**REVIEW COMMENTS ON ESF ALCOVE GROUND  
SUPPORT ANALYSIS AND ESF GROUND  
SUPPORT—STRUCTURAL STEEL ANALYSIS**

**Nuclear Regulatory Commission  
Contract NRC-02-93-005**

**Center for Nuclear Waste Regulatory Analyses  
San Antonio, Texas**

**January 1997**

Figure 1. Variation of Q values along North Ramp and associated support categories (from Williams, 1996).

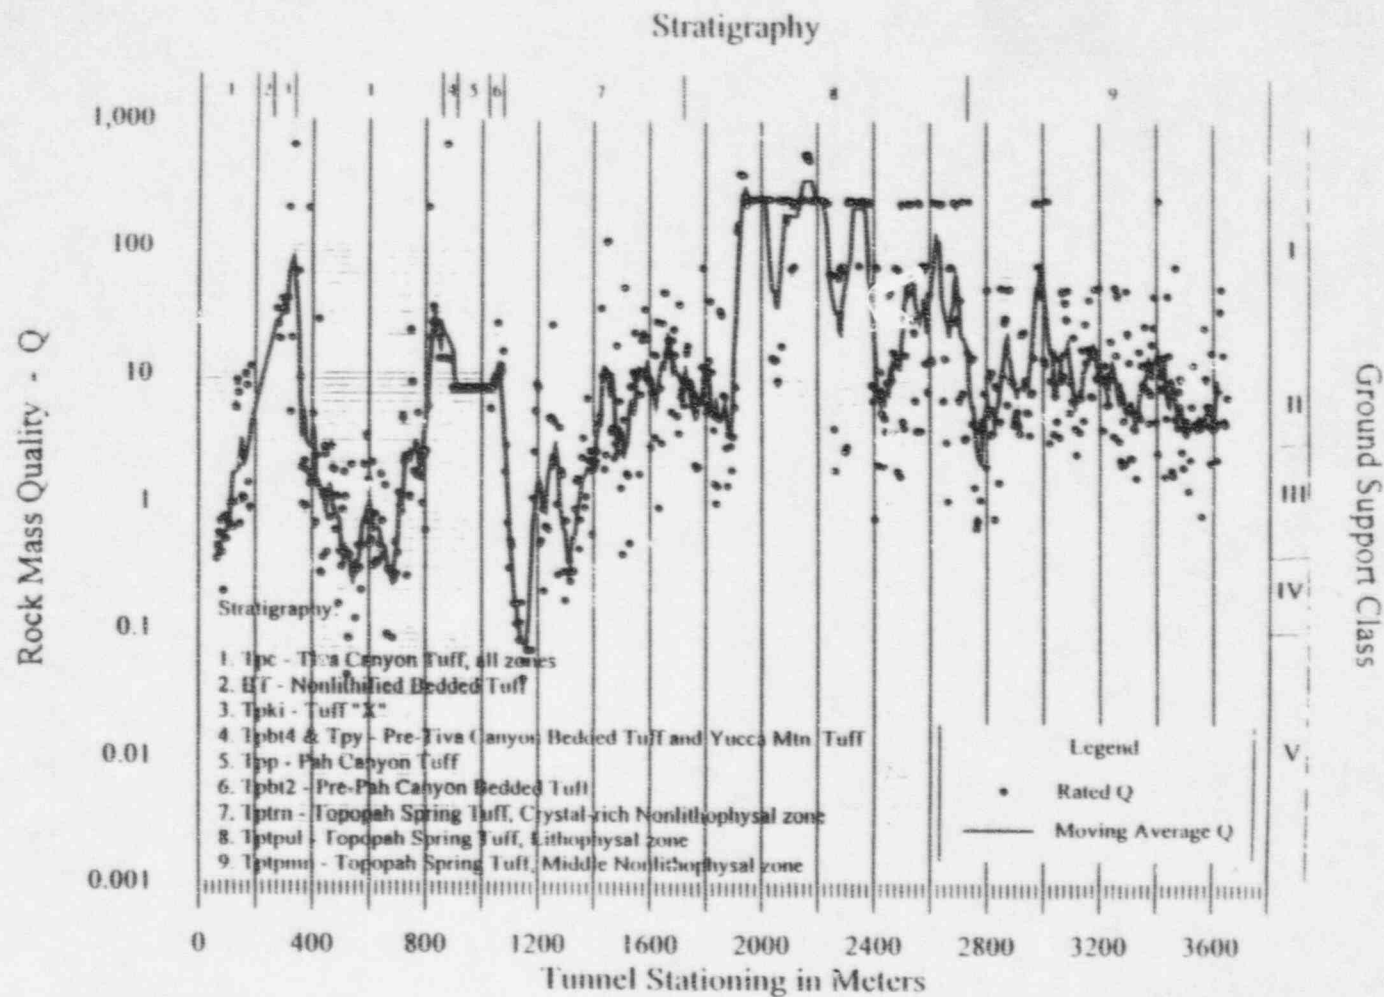
Figure 1 from Williams (1996) illustrates the relationship along with the measured Q values and moving average. In this figure, different TM units are shown for identification purposes only along the ESF tunnel. This methodology is acceptable and causes less confusion than the previous methodology which created different meanings of rock mass quality in different TM units.
